RE: JMC Project 20101
Summit Club Residential
Bedford Road (Route 22)
Town of North Castle, NY

Response to Town Comments Resubmission

Town of North Castle Planning Department, dated January 19, 2021

1 GATEHOUSE PLAN
 SCHEMATIC

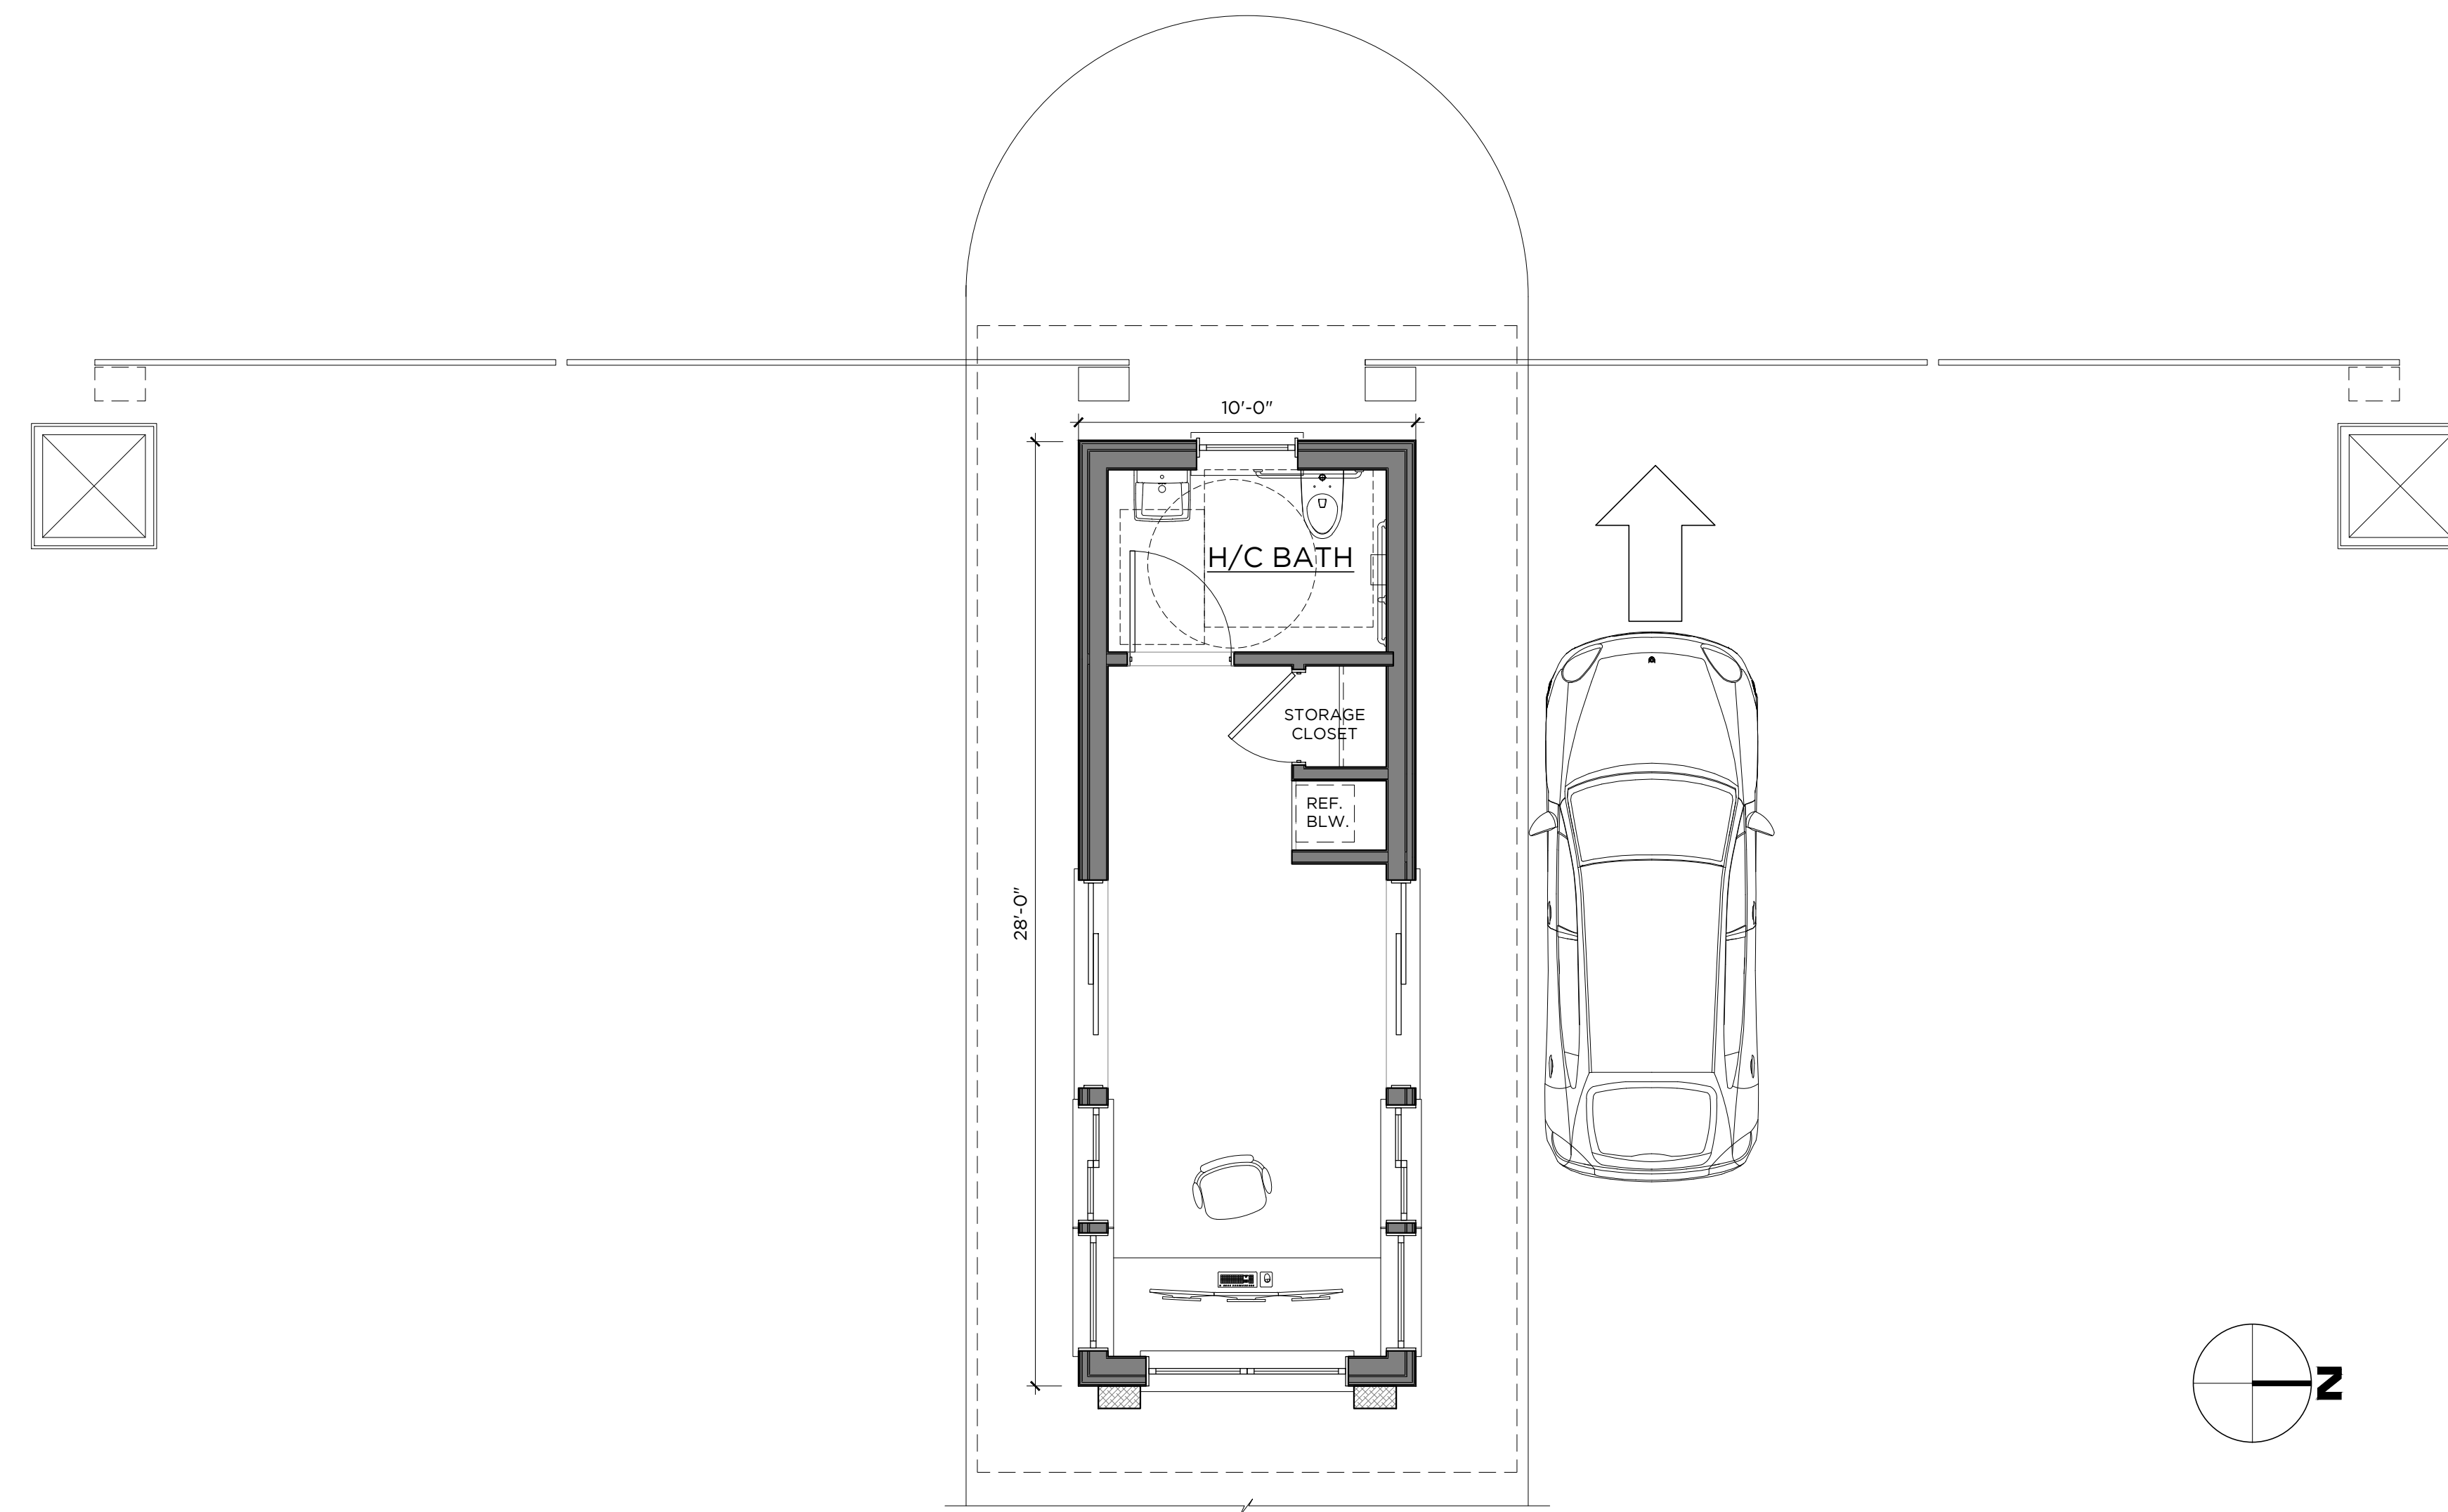
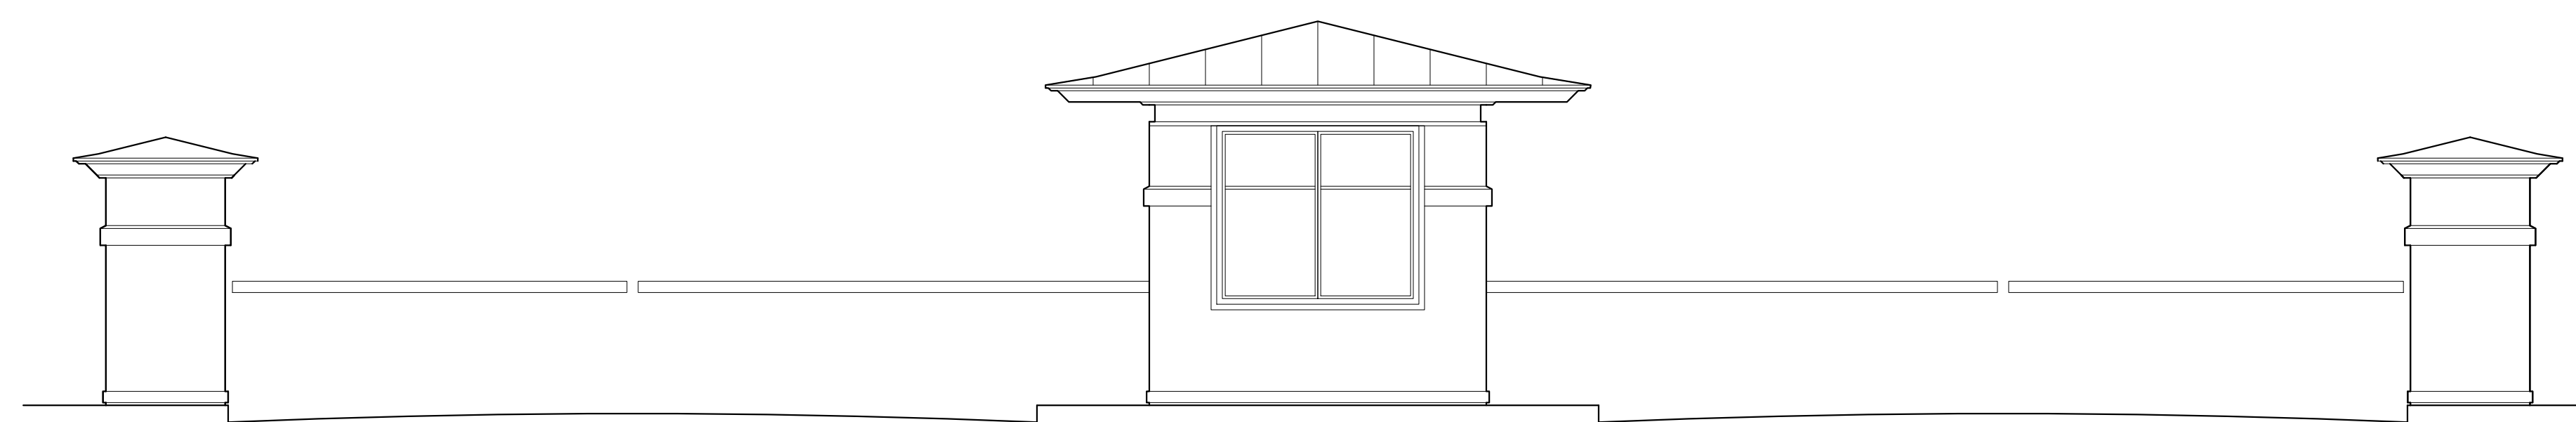
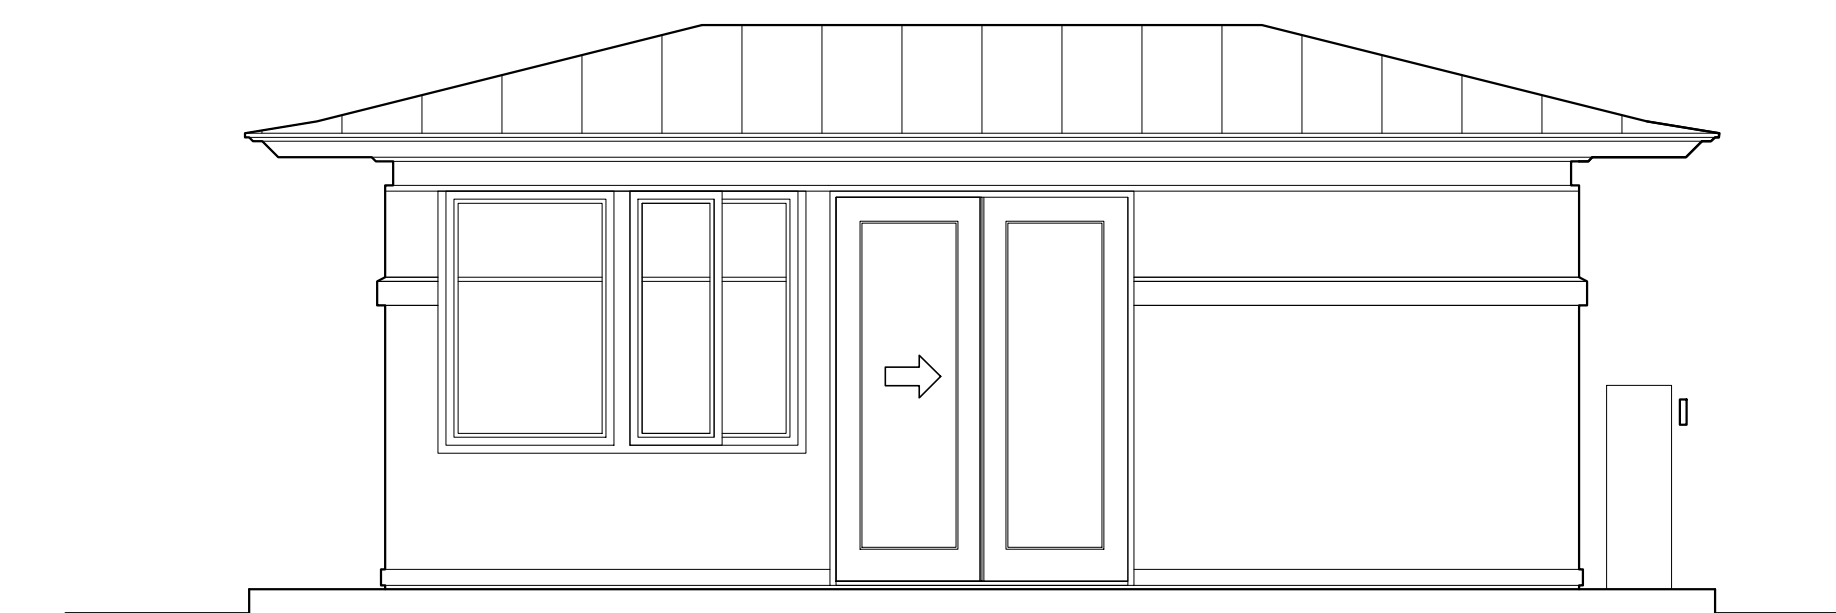
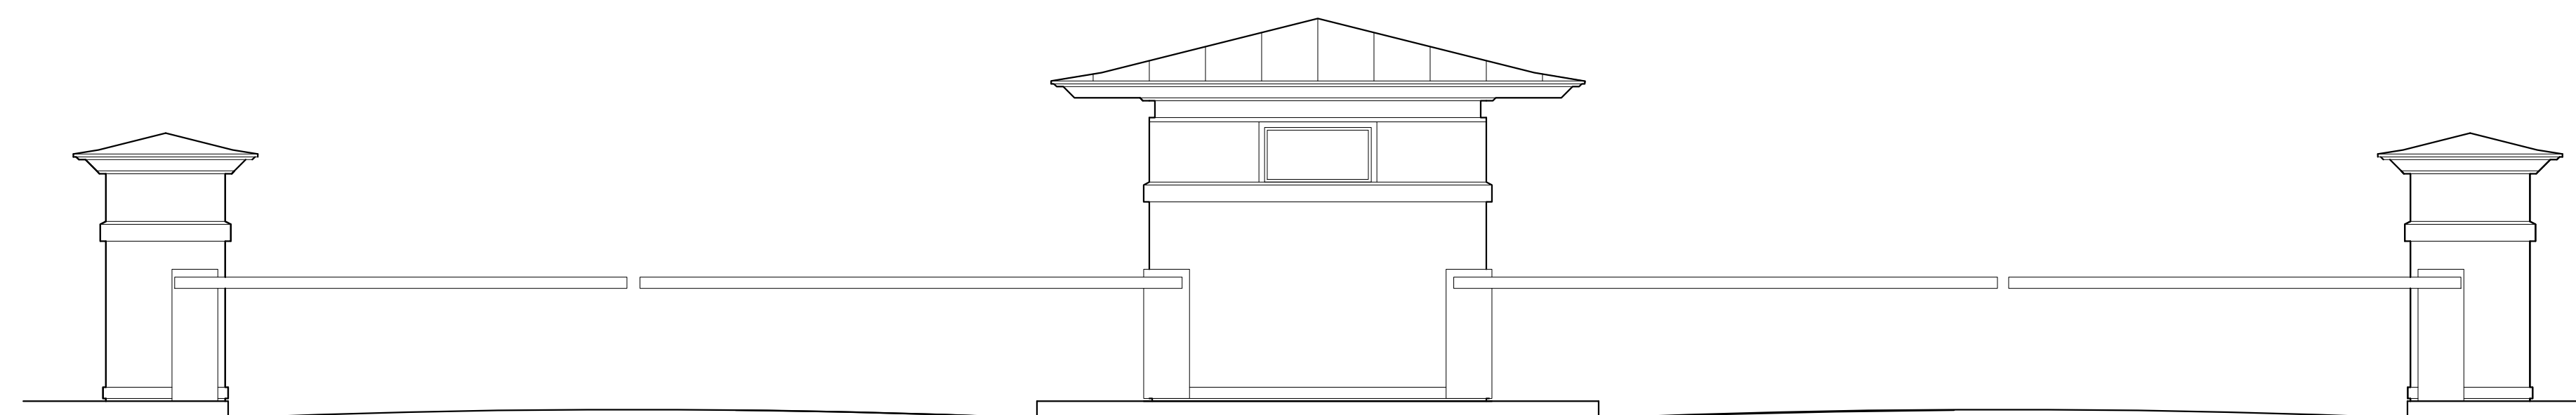
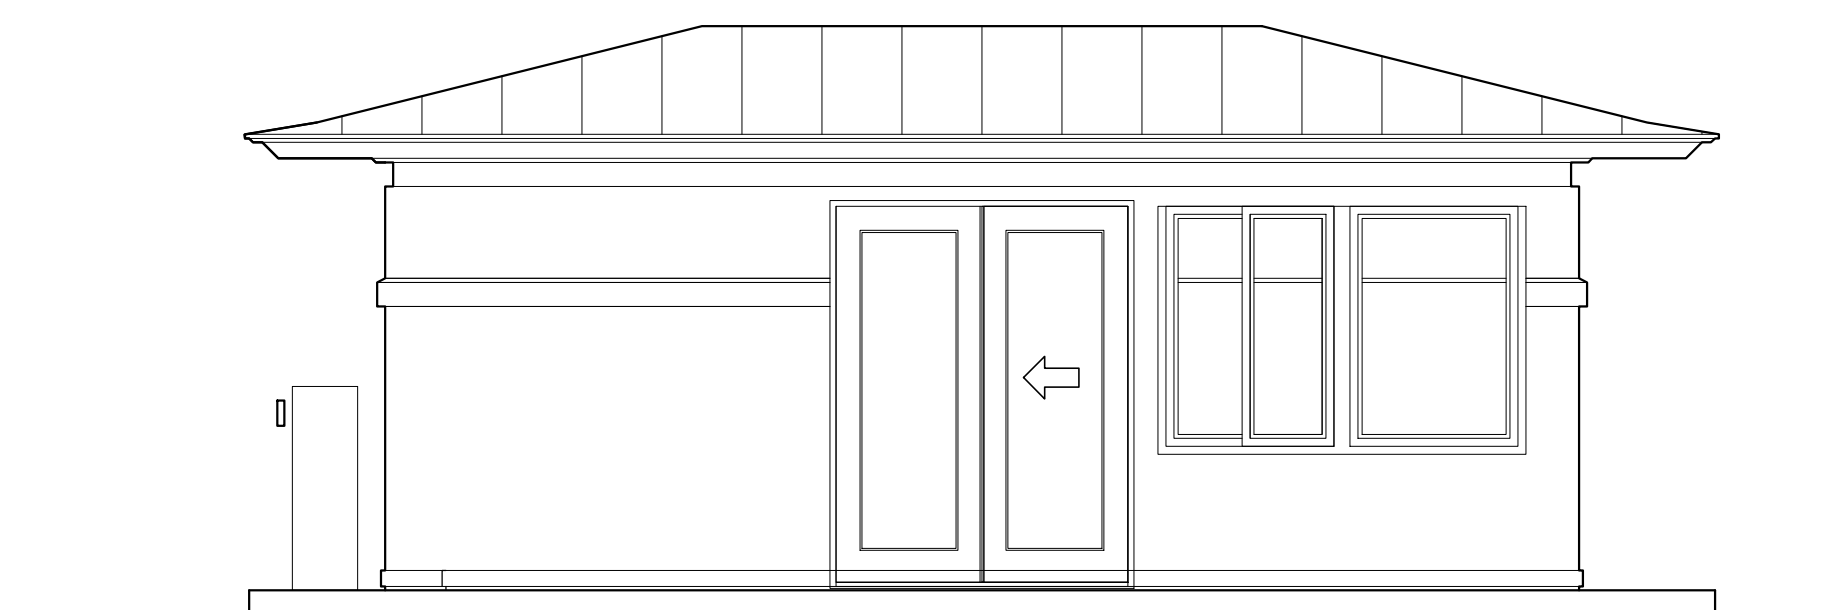
The Applicant should submit floor plans and elevations of the proposed gate house for review.

Floor plans and elevations of the proposed gate house have been submitted in this application and are also depicted in the site plan and renderings.
